MOONEY INTERNATIONAL CORPORATION SPECIAL LETTER

SPECIAL LETTER 18-19

- SUBJECT:** To ADVISE MOONEY OWNERS/OPERATORS of the **Continental Motors Aircraft Engine SERVICE BULLETIN SB18-08, Dated: 12/10/2018 - Subject: Inspection and Maintenance Modifications of Cylinder Assemblies.**

- SUBJECT:** Inspection and Maintenance Modification of Cylinder Assemblies
- PURPOSE:** To inspect and remove casting material build-up on the radius edge of identified cross-flow cylinder heads.
- COMPLIANCE:** If under 500 hours in service, perform radius blend inspection and modification no later than the next scheduled 100-Hour/Annual inspection. If 500 hours or greater, perform radius blend modification at the next maintenance event (not to exceed 50 hours).
- MODELS**
- AFFECTED:** All Continental Motors (CMI), GTSIO-520-C, D, H, K, L, M, N; IO-550-G, N, P, R; IOF-550-N, P, R; TSIO-520-BE; TSIO-550-A, B, C, E, G, K, N and TSIOF-550-D, J, K, P aviation gasoline (AvGas) engines originally manufactured, rebuilt, or modified with a cross-flow cylinder replacement on or after 01 NOV 2014.

Figure 1. Affected Cross Flow Cylinders, Top Fin Flange typical

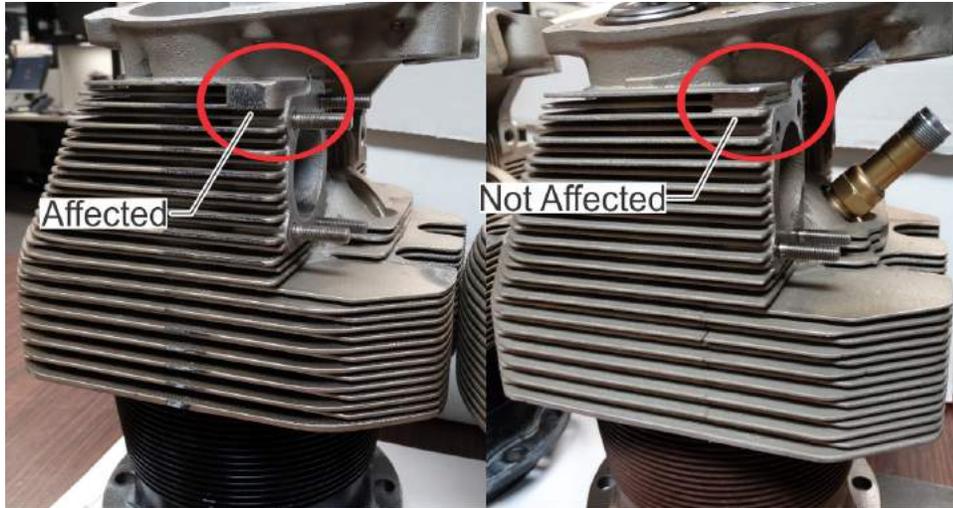
Several field reports indicate the potential for fracture initiation on engines (exceeding 500 hours of operation) at the radius edge of identified cylinder heads produced on or after 01 NOV 2014 (see Figure 2). The affected cylinder casting can be identified by the “filled” top fin flange area above the exhaust port as shown in Figure 1.

Figure 4. Smooth Radius Corner after Radius Blend Modification

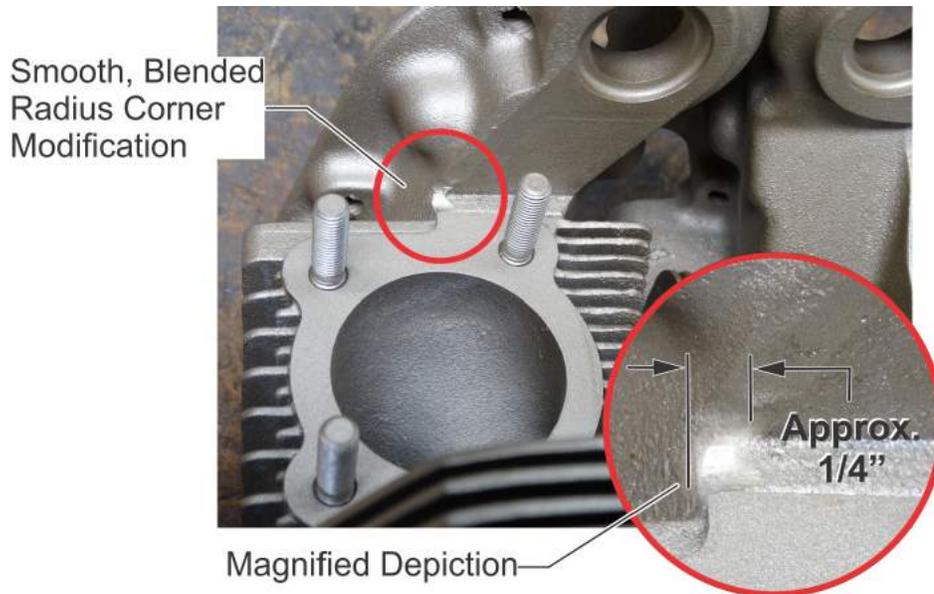
2. If the cylinder head exhaust ear is not stamped with the letter “S” or is obscured by baffling, inspect the radius corner angle below the exhaust port (see Figure 5) for any casting flash build-up or sharp radius edges. The radius corner should be tapered and blended smooth (reference Figure 4).

Carefully, vary your filing motion until a smooth, blended “tapered” radius edge is achieved at the radius corner. Remove ONLY enough material from the cylinder head to achieve dimensional specification, see Figure 4. The finished radius blend should not exceed 0.20” depth of the material removed.

5. Inspect the cylinder head surface and remove all nicks, burrs, sharp angles or edges using a de-burring tool and Scotch-Brite© (ultra fine or equivalent). Evenly shape, taper, and smooth all interfering surfaces where material was removed (see Figure 4).
